**Notice of decision on your access application under the
*Government Information (Public Access) Act 2009 (GIPA Act)***

All information (initially as a list), regarding the design of the truck arrester bed for the Mona Vale Road East Upgrade, specifications and design calculations, and internal correspondence for the "PV" Arrester Bed.

Road Safety Audit report

MR 162 Mona Vale Road, between Manor Road, Ingleside and Foley Street, Warriewood - Widening to 4 Lanes.

SECTION @ ST 2230 URBAN DESIGN CONCEPT

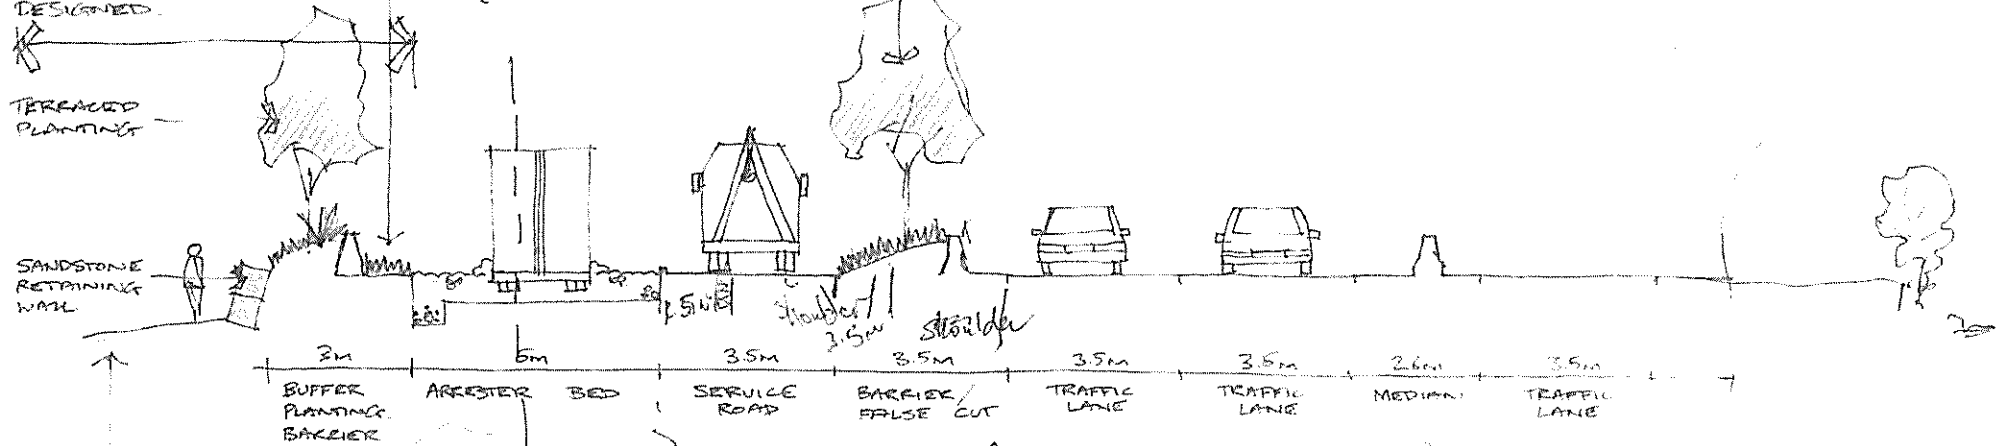
INTERFACE BETWEEN ARRESTER BED AND EXPANSION OF CEMETERY TO BE DESIGNED.

NATIVE GRASSES IN FRONT OF BARRIER TO SOFTEN VISUAL IMPACT

FRANGIBLE PLANTING BEHIND BARRIER TO SOFTEN VISUAL APPEARANCE OF ARRESTER BED

Figure 2: Updated proposed intersection layout showing the removal of slip lane, and retaining bus priority treatment (bus lanes in red)

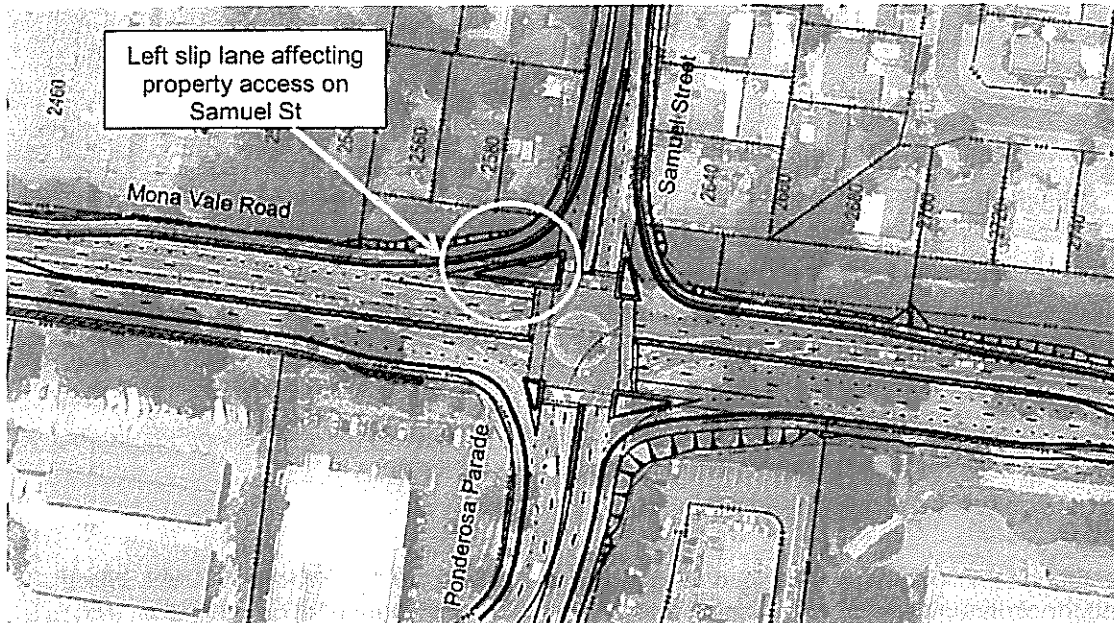
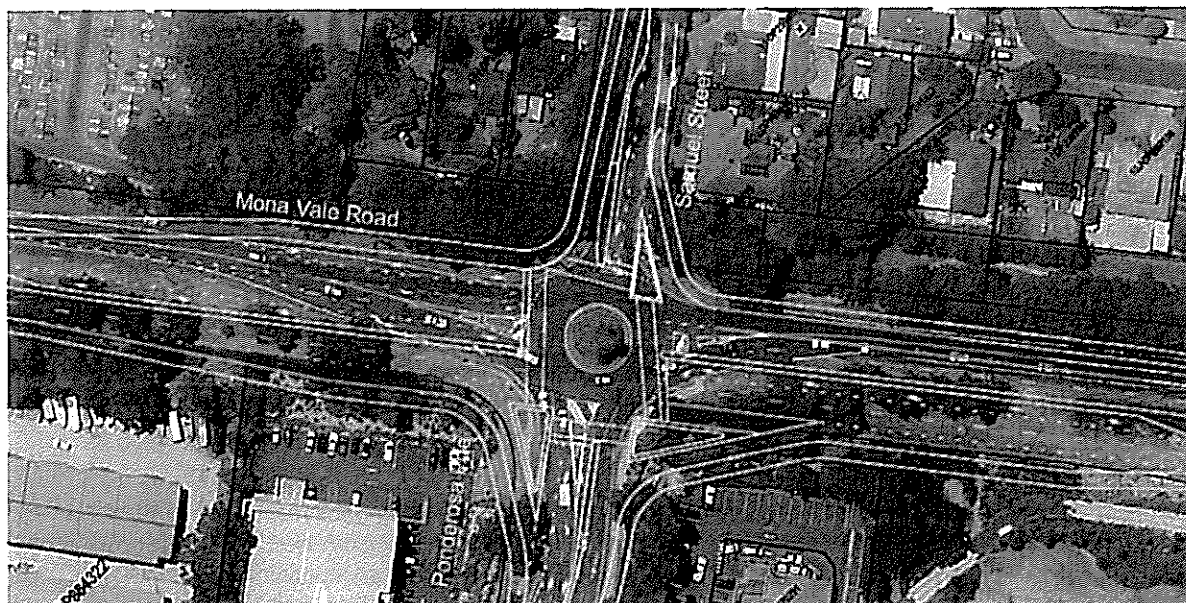
In response to community feedback regarding property access impacts, the proposed left slip lane from Mona Vale Road to Samuel Street (north-west corner) has been removed to minimise property access impacts to properties on Samuel Street near the signals. The length of the concrete median on Samuel Street has been revised to enable right turning property access for properties on the north east corner.

It is proposed to further widen the Mona Vale Road west approach to retain the bus priority provision (bus lanes shown in red in Figure 2). An updated intersection performance analysis by SIDRA indicated acceptable level of service for forecasted traffic at the intersection over the analysis horizon (year 2036 with the full Mona Vale Road upgrade, summary results in Attachment 1). A supplementary traffic and transport assessment will be included as part of the Submissions Report reflecting the proposed changes to this intersection.

Figure 2: Proposed new alignment for the off road shared path and utility corridor

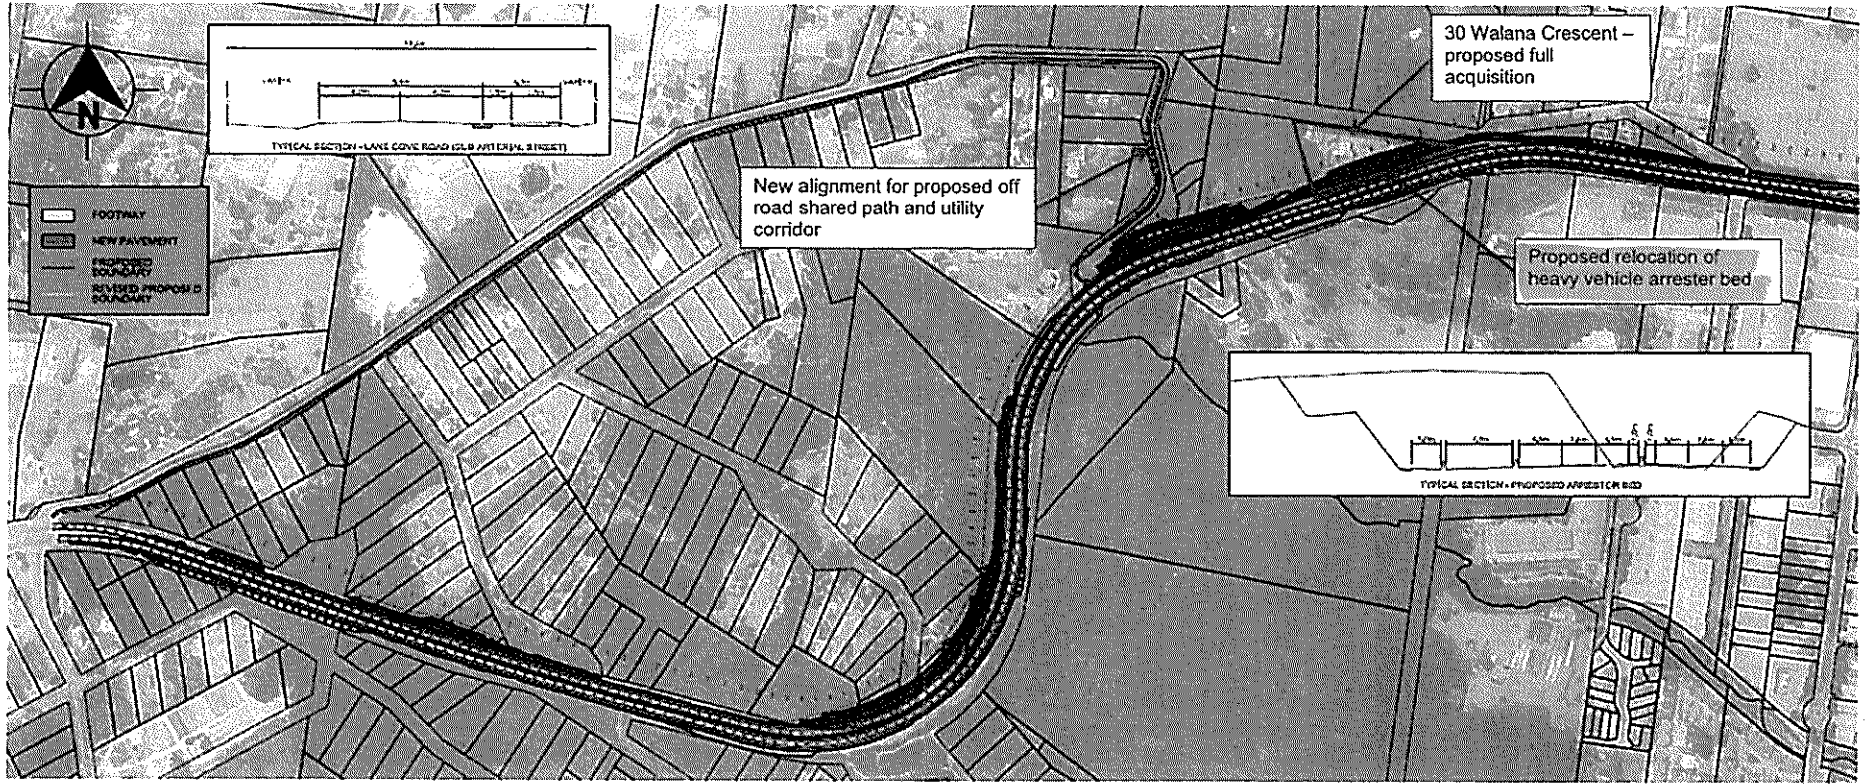
RMS Design section has modified alignment for the off road shared path and utility corridor on Lane Cove Road without connecting to Walana Crescent (Attachment 3). This resulted in further widening of the Mona Vale Road near property 30 Walana Crescent. The property 30 Walana Crescent has two existing access^s from Mona Vale Road and Walana Crescent. The proposed road upgrade would prohibit access from Mona Vale Road due to a major cutting in the design. The proposed relocation of the off road shared path would further require additional land take from this property.

- A new proposed alignment for the off road shared path and utility corridor on Lane Cove Road which is still within the assessment of impact described in the REF
- Full acquisition of property 30 Walana Crescent. There is an increase in property acquisition cost. However, it is expected this additional property cost could be offset by other property acquisition savings from Ponderosa Parade/ Samuel Street intersection. Further, land which would subsequently not required near Walana Crescent could potentially benefit plans for the Mona Vale cemetery expansion as indicated by the submission from Pittwater Council.
- **Arrester bed relocated to a better position as a response to a corrective action from the concept design road safety audit**
